ARCHITECT'S SUPPLEMENTAL INSTRUCTIONS

PROJECT:	The Reserves at South Lake New Apartment Complex Grinnell, IA	Report No.	Three (3)
OWNER:	OPG South Lake Partners, LLC Dan Maximuk 234 N. Santa Fe Ave, Suite A Salina, KS 67401	Date	January 18, 2022
CONTRACTOR:	MCP Group 3501 SW Fairlawn Rd. Topeka, KS 66614	Architect's Proj No.	20-3118
		Contract For:	General Construction Mechanical, Electrical

IFA Plan Review

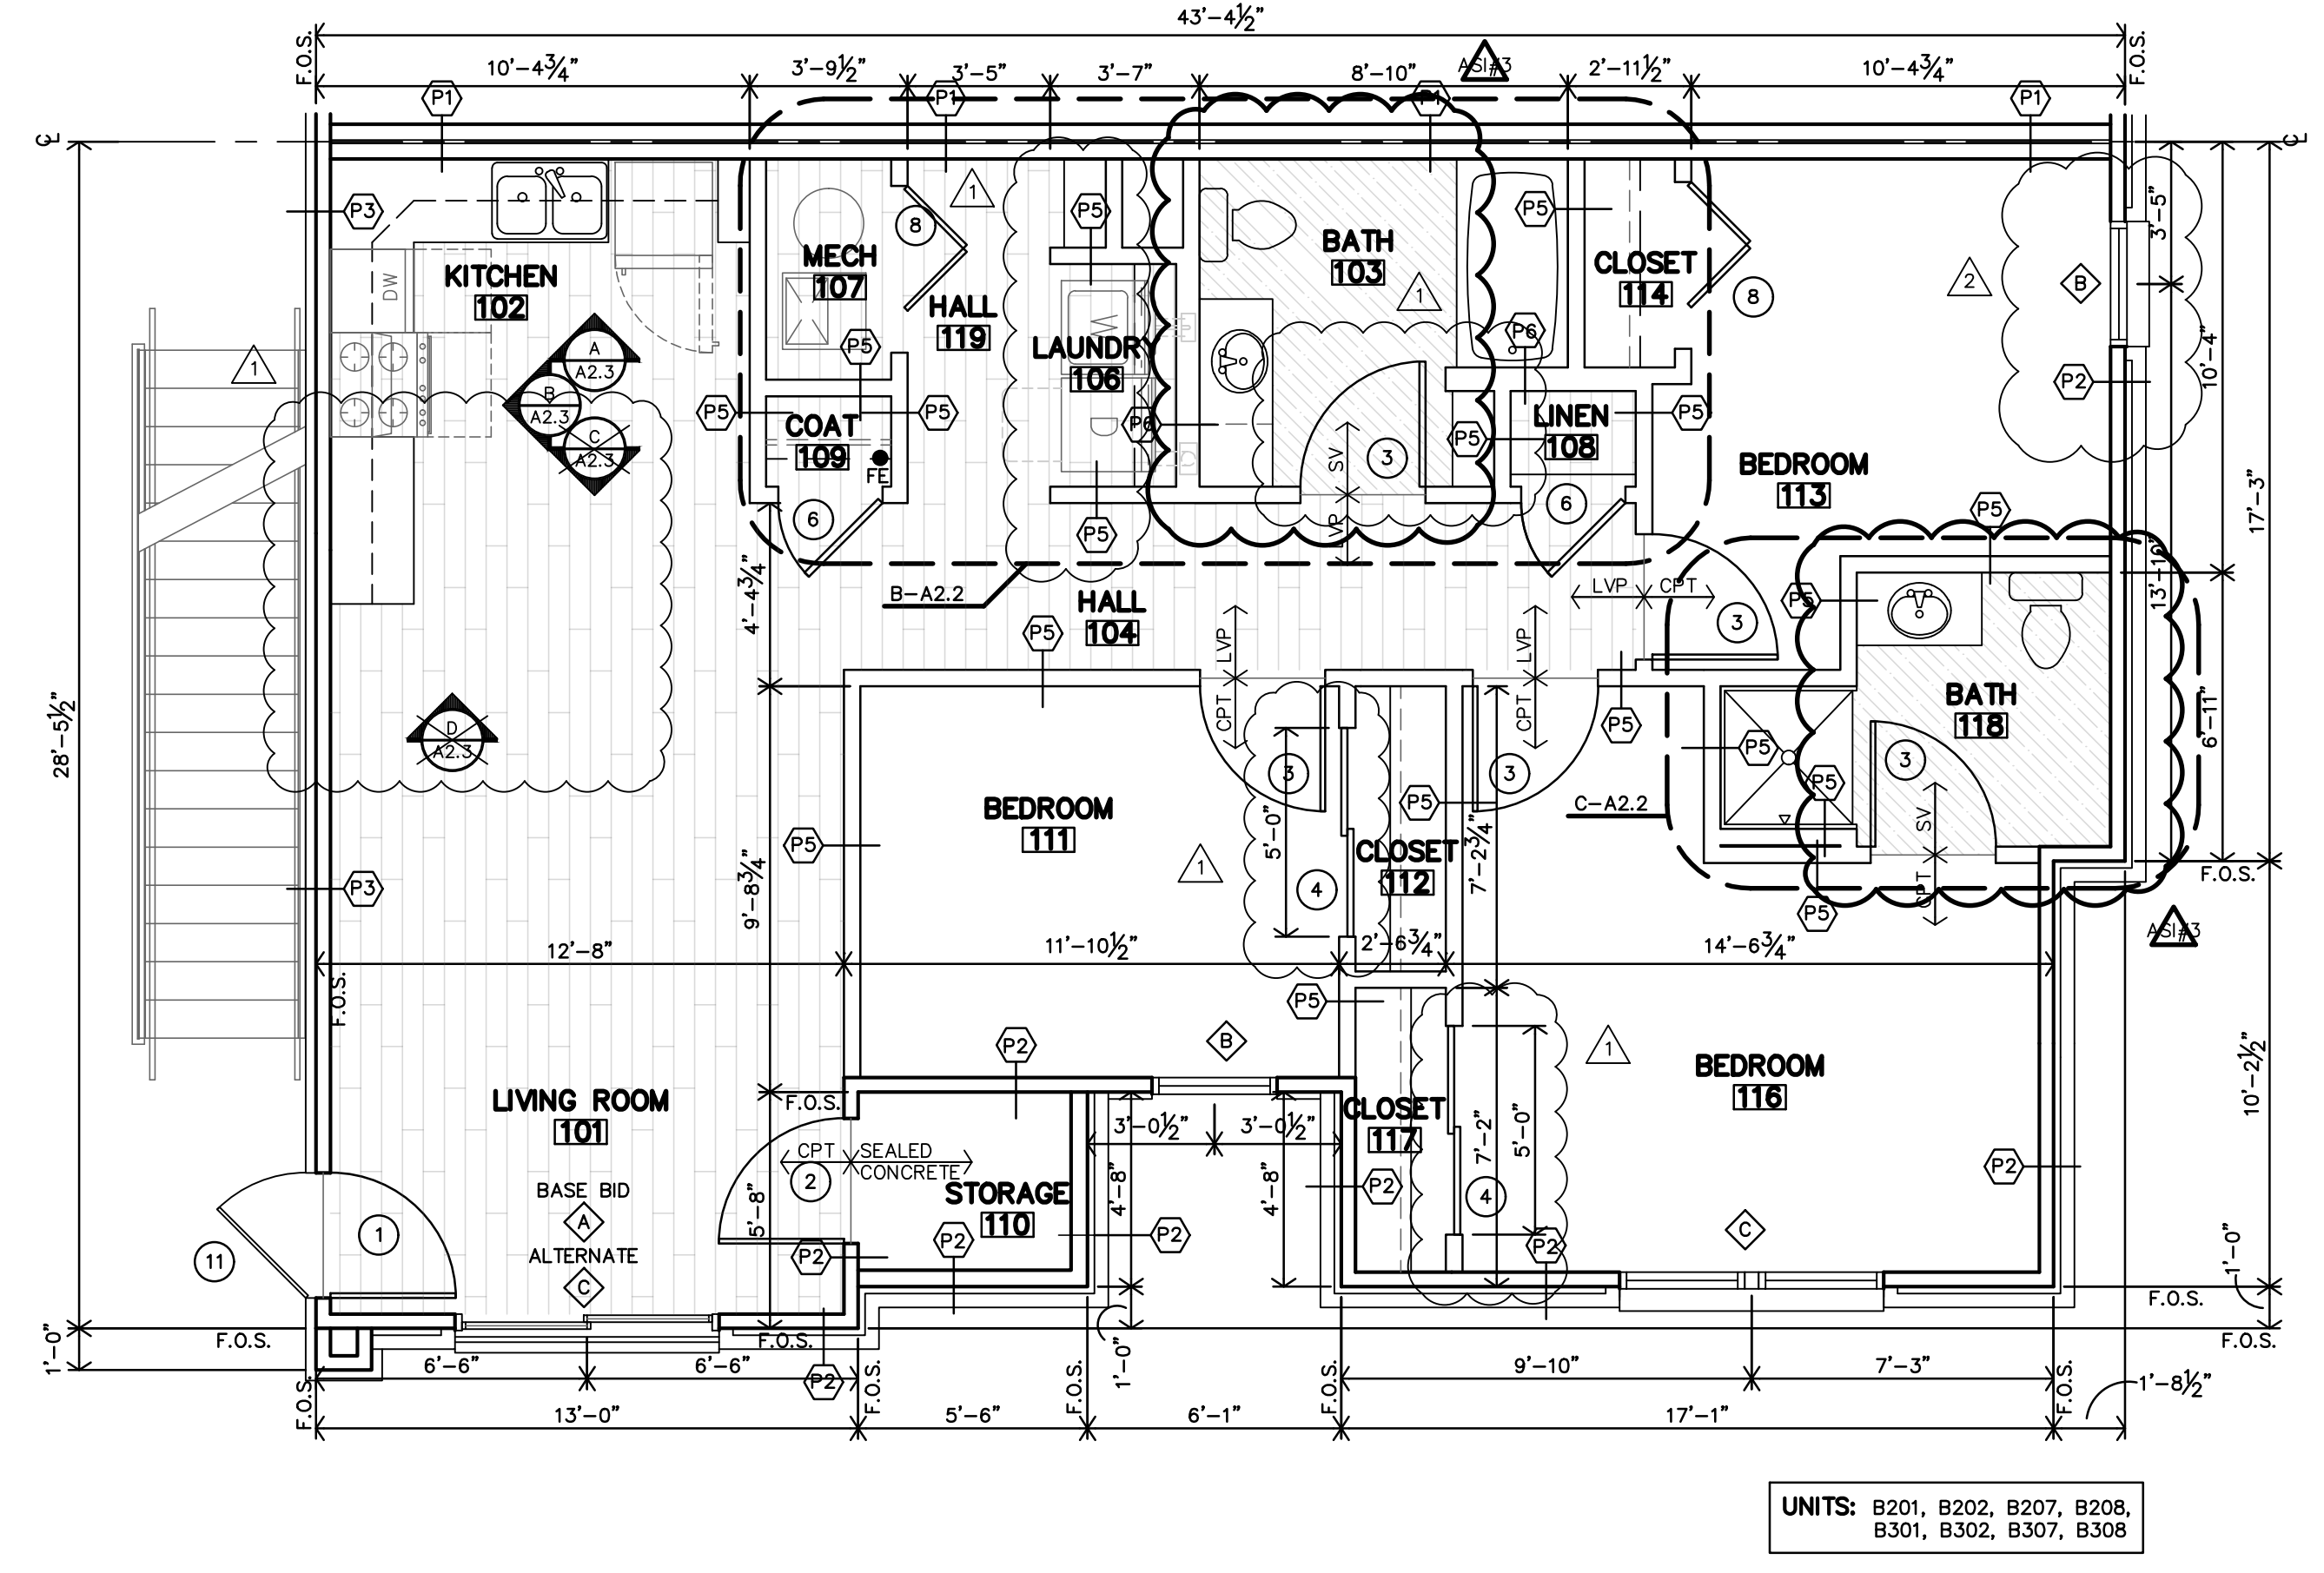
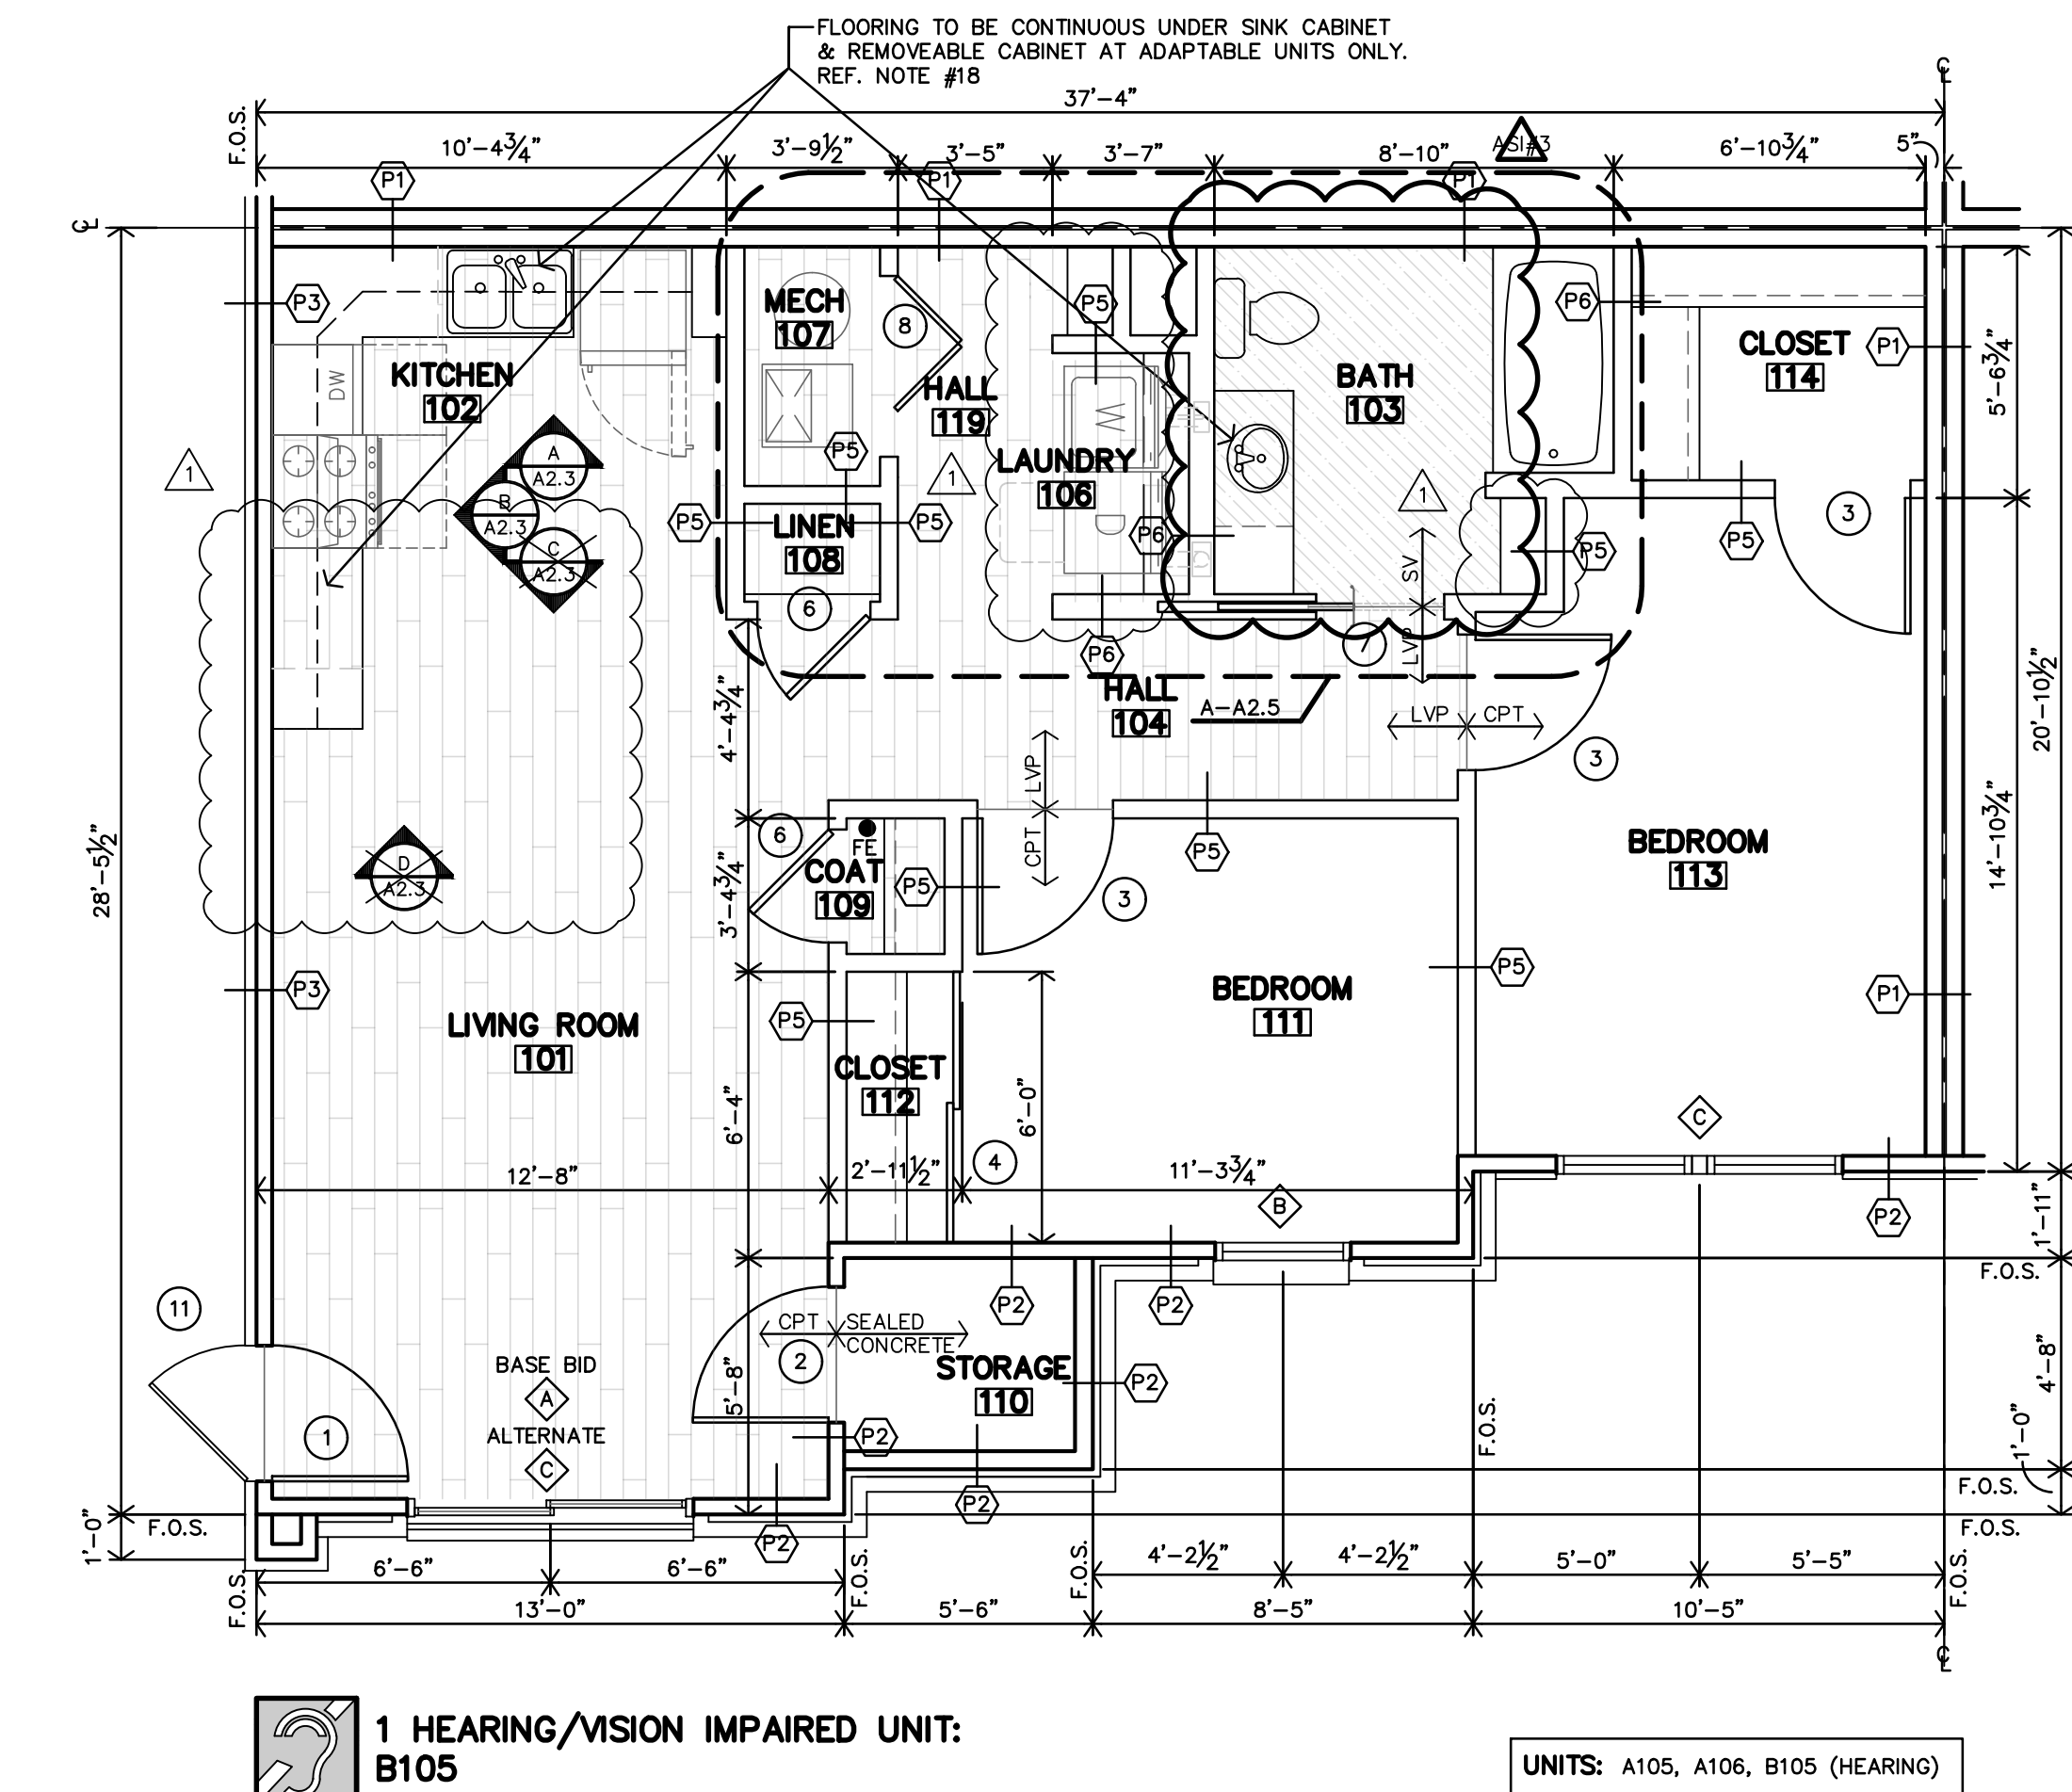
1. IFA Plan Review and Responses is attached for reference. Associated revised drawings and specifications attached and listed below
 - a. Drawings
 - i. Sheet A2.1 – Floor Plans A, B, C & D – Finished flooring material in Baths have been changed to Sheet Vinyl.

8. Bathroom floors must be a sheet vinyl product that meets QAP requirements. See G.6.3 in Part C – Threshold Requirements... Sheets A2.1, A2.2 and A2.4 have been revised to show bathrooms floors as Sheet Vinyl product. Specifications have been revised as well. Attached.
